ADMINISTRATIVE APPLICATION CHECKLIST

Re: Application for Authorization to Inject
OCD Form C-108
Central Vacuum Unit
Lea County, New Mexico

Chevron North America respectfully requests administrative approval to convert the Vacuum Glorieta West Unit #82 (API # 30-025-31840) to Central Vacuum Unit #373 WAG Injection well in the Grayburg San Andres formation. The Central Vacuum Unit #373 is located: 2576' FSL & 149' FEL, Unit Letter I, Section 36, T17S, R34E, Lea County, New Mexico.

Re: Vacuum Glorieta West Unit #82 (to be Central Vacuum Unit #373) – Permit to Inject

**Proposed
WELLBORE DIAGRAM
Convert to CVU 373**

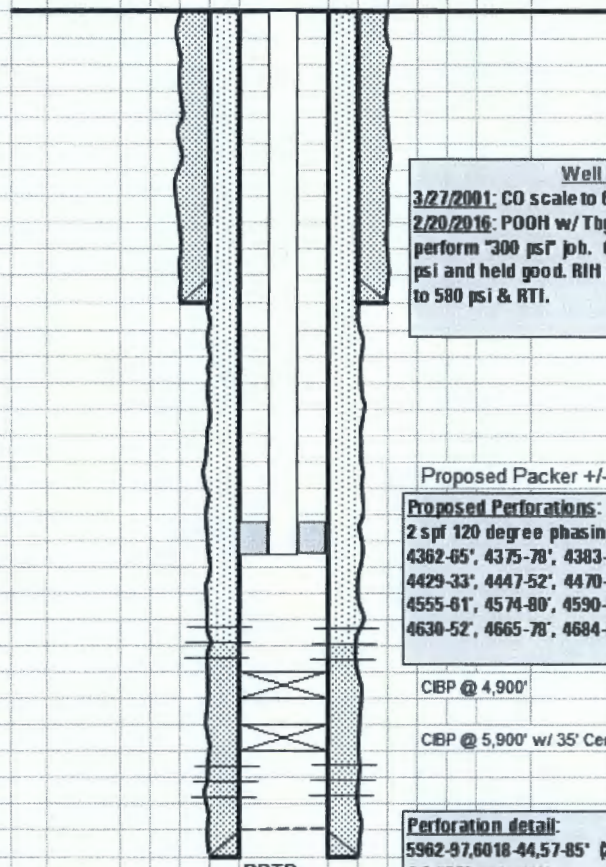
Cindy:
The OCD is concerned about the proposed well bore diagram in the Vacuum Glorieta West Unit Well No. 82. Chevron is proposing approximately 1200 feet between the lowest perf and the plug.
The OCD would prefer the plug to be approximately 200 feet below the bottom perf.
